#2021-01 Crystal Lake Public Library – Variation Project Review for Planning and Zoning Commission

Meeting Date: January 20, 2021

Requests: A variation from Article 3-200 Table 3-200A to allow an

Location: 126 W Paddock St

PROPOSED SITE IMPERVIOUS

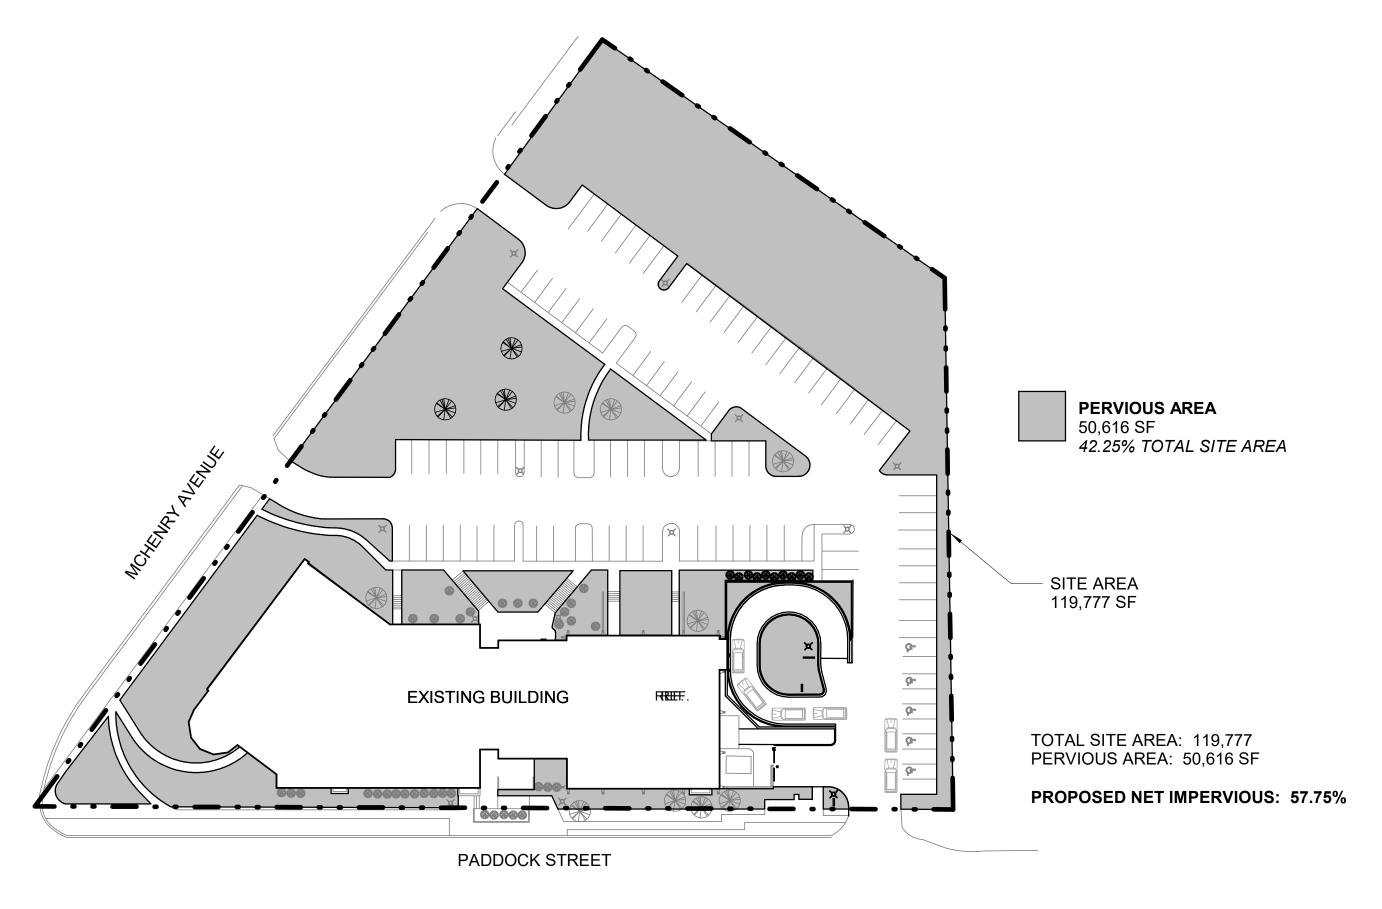
- The existing impervious surface coverage exceeds the UDO standards. The existing impervious surface coverage is 55.6%.
- The proposed impervious surface coverage is 57.75%, an increase of 2.15% (2,104 square feet).
- The increase in the impervious surface coverage is required to allow for the addition of a drive-through book pick-up and return.
- There is not any existing impervious surface that could be removed to bring the Library closer to the ordinance requirement.
